From: [REDACTED]
Sent: 13/11/2025 12:46:52 PM
To: Council Northernbeaches Mailbox
Cc: Emma Tonkin
Subject: TRIMMED: RE: DA 2025/1570; 290 LOWER PLATEAU ROAD, BILGOLA PLATEAU WRITTEN SUBMISSION: LETTER OF OBJECTION SUBMISSION: TULLOCH
Attachments: 290 LOWER PLATEAU WS.pdf;

EMMA TONKIN, 286 LOWER PLATEAU ROAD, BILGOLA PLATEAU

13 NOVEMBER 2025

RE: DA 2025/1570
290 LOWER PLATEAU ROAD, BILGOLA PLATEAU
WRITTEN SUBMISSION: LETTER OF OBJECTION
SUBMISSION: TULLOCH

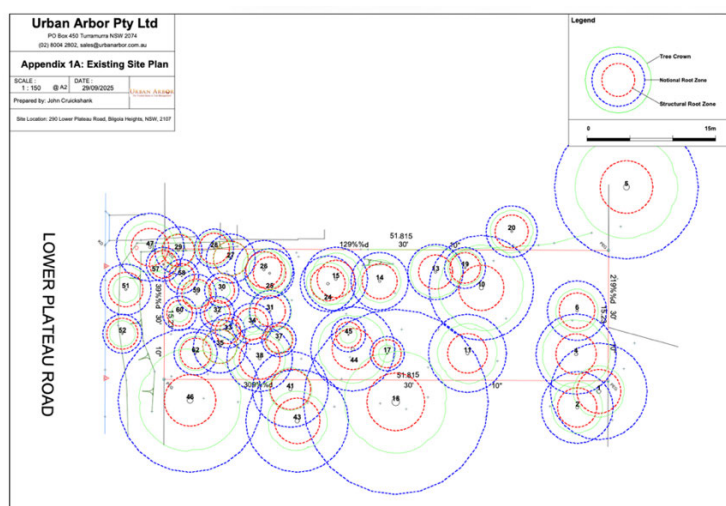
The Applicant is requesting a further 12 Trees to be removed for Z1, Z6, Z10 & Z12 reasons. Council will need to assess these matters to ensure that Council's Officers agree with the assessment:

- Tree 14: 7m *Eucalyptus resinifera*, [Red Mahogany] Z4 – dieback, termites
- Tree 17: 8m *Allocasuarina littoralis* [Black She Oak] Z10 – crown shape
- Tree 24, 9m *Angophora costata* [Smooth Barked Apple] Z10 – crown shape
- Tree 32, 8m *Corymbia gummifera* [Red Bloodwood] Z1 -suppressed
- Tree 34, 8m *Allocasuarina littoralis* [Black She Oak] Z4 – poor condition
- Tree 37, 7m *Corymbia maculata* [Spotted Gum] Z1 – crown shape
- Tree 38, 8m *Eucalyptus haemastoma* [Broad Leaved Scribbly Gum] Z10 - stem
- Tree 44, 9m *Angophora costata* [Smooth Barked Apple] Z10 – crow, leader
- Tree 45, 6m *Elaeocarpus reticulatus* [Blueberry Ash] Z11 - crown
- Tree 51, 3m *Allocasuarina littoralis* [Black She Oak] Z6 - root plate
- Tree 52, 7m *Angophora costata* [Smooth Barked Apple] Z10 - lean
- Tree 60, 6m *Angophora costata* [Smooth Barked Apple] Z1 - lean
